APPLICATION FOR IMPROVEMENT PERMIT FOR RESIDENTIAL SITE INDIVIDUAL WATER AND WASTEWATER SYSTEMS PROGRAM

SOIL/SITE EVALUATION *for* ON-SITE WASTEWATER SYSTEM

Re: Hawfield Road
File: 1768B
Parcel: 053-093-33

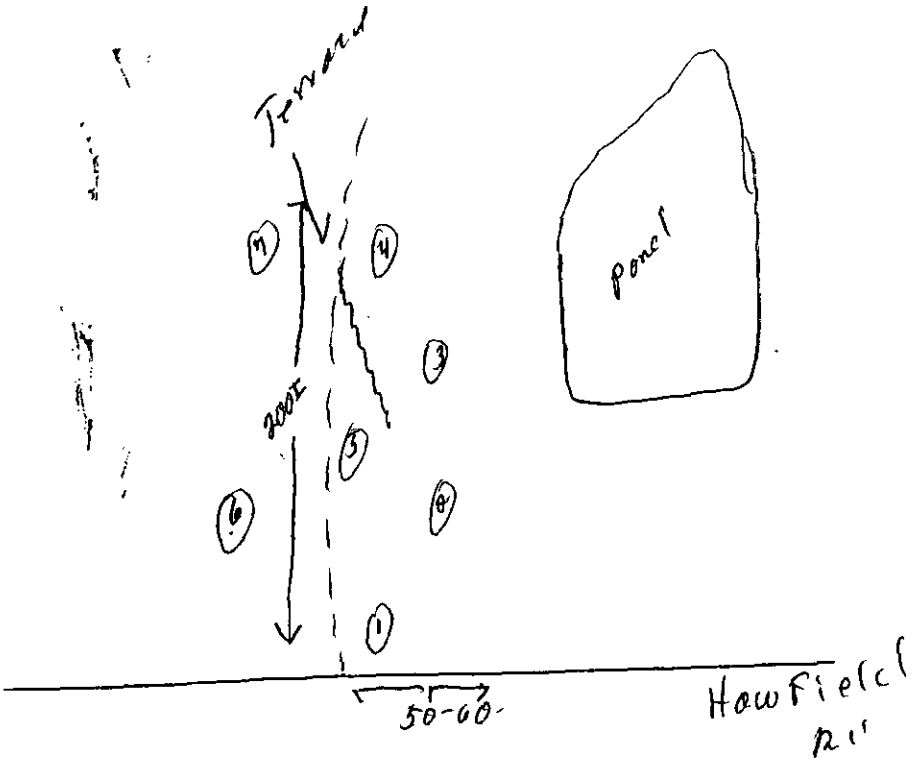
OTHER FACTORS (.1946): ___
SITE CLASSIFICATION (.1948): Unsuitable
EVALUATED BY: W.A. Merlin 3-1997
OTHER(S) PRESENT: LSS

OMMENTS: 100' perc

Boring 1 & 2 ~~is~~ test also used needed

SOIL/SITE EVALUATION *for* ON-SITE WASTEWATER SYSTEM

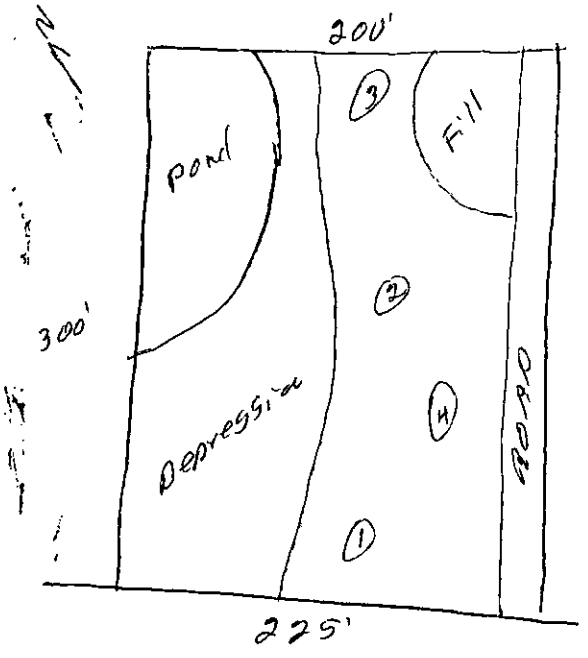
OTHER FACTORS (.1946):
SITE CLASSIFICATION (.1948): Unsuitable
EVALUATED BY: William A. Marks 3-4-99
OTHER(S) PRESENT: LSS

OMMENTS: 1006 Repair
